Department of Environmental Quality

**RE: Request for Information
North Pacific Division Laboratory
ECSI No. 1390
Troutdale, Oregon**

As we discussed yesterday, the Oregon Department of Environmental Quality (DEQ) is requesting additional information regarding the U.S. Army Corps of Engineers (COE) North Pacific Division (NPD) Laboratory site. The site is located at 1491 Northwest Graham Road within the city of Troutdale, Oregon. This information is requested to assist DEQ in evaluating and addressing complaints regarding former practices at the laboratory that may have resulted in releases of hazardous substances to the environment.

FIGURE 2

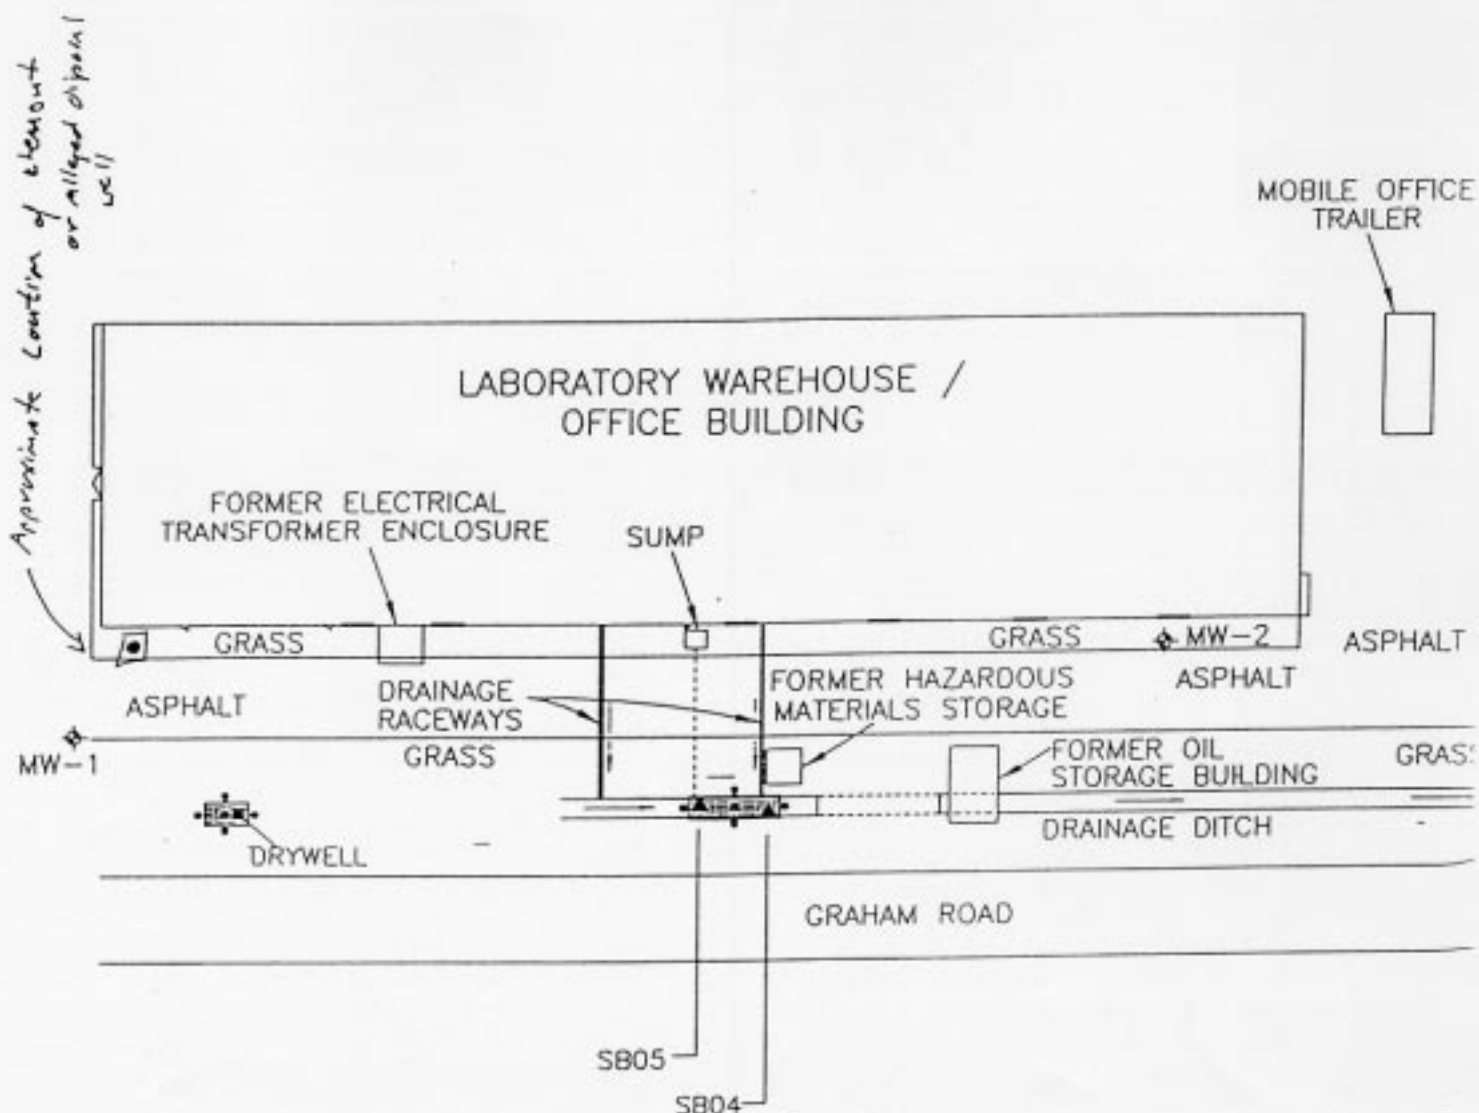
DEQ received information regarding an alleged disposal well near the southeast corner of the building. The location of this feature is shown on the attached figure. This feature is an approximate

2 foot by 2 foot concrete structure with an approximate 6-inch diameter cylindrical opening. The opening has been plugged with concrete. During the March 14, 2001, site visit with EPA, this feature was identified as a drainline cleanout. Please provide DEQ and EPA with a description of the items listed below. Copies of any documents consulted, examined or referred to should be provided to DEQ and EPA.

- a) Purpose of structure;
- b) Map of laboratory sewer/drainage system; and
- c) If this feature is identified as a disposal well, provide all information available regarding the type and quantities of wastes disposed in this well, period of disposal, frequency of disposal, disposal practices, and results of any analytical testing performed.
